Comments for Planning Application 24/00845/P

Application Number: 24/00845/P

Address: 1 Quondrom Cottages Yester Gifford Haddington EH41 4JZ

Proposal: Change of use of grass verge to form additional garden ground, erection of fencing and outbuildings, formation of hardstanding and decked areas, installation of air source heat pump,

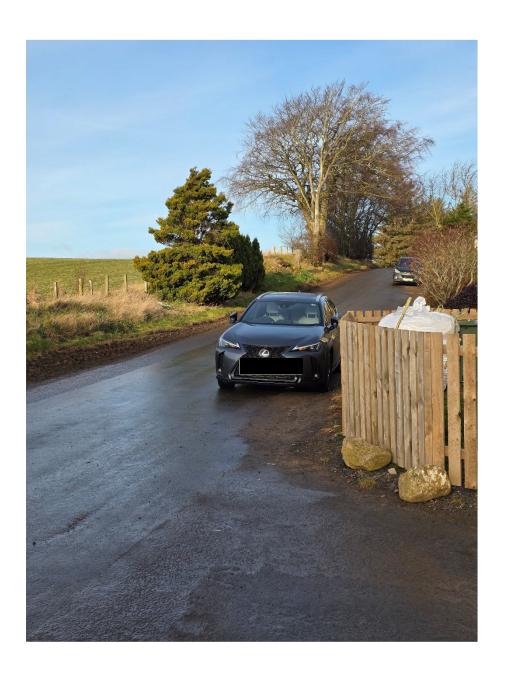
The sunrooms size 2.5 m high 3.5 m wide and is too large for the space and too close to the current leehouses cottages boundry as well as the cottage itself and thus spoils the character of Quondrom cottages

The sauna outbuilding is also too close to the garden boundary to number 2 Quondrom Cottages and obscures the afternoon sun as well as again spoiling the character of the cottage property.
